Heckington Fen Solar Park

EN010123

Change Notification Consultation– Information Leaflet

Document Reference: PreExA.IL.CN.V1

-  Proposed Order Limits
-  AW1 extension for bus-coupler
-  AW2 extension for new CSE*
-  Accepted DCO Order Limits

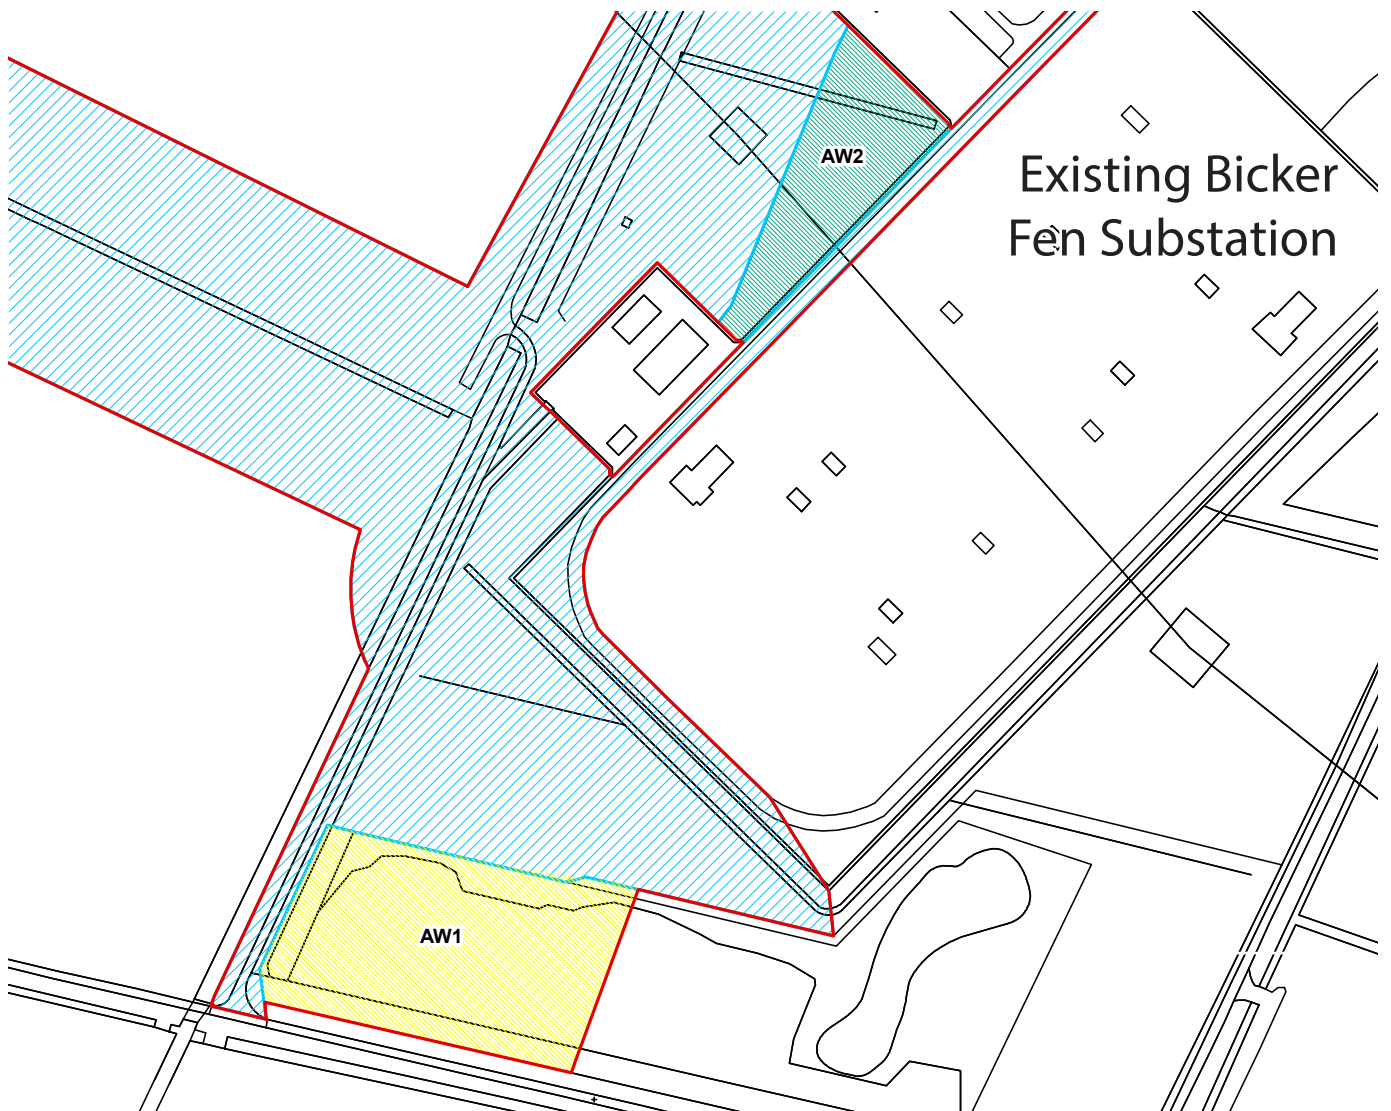
- a new section of NGET infrastructure at the substation comprising a busbar extension including a section breaker, a bus coupler and a feeder circuit on land to the south of Bicker Fen Substation (AW1) ; and
- a new cable sealing end compound (CSE) on land to the west of Bicker Fen Substation (AW2); together known as, the "Additional Works".

Accordingly, a larger area (of approximately 0.9ha) is needed to deliver the Additional Works and to facilitate the Applicant's connection into the Bicker Fen Substation. The full extent of the land area covered by the change is shown in yellow and green hatching on plan overleaf.
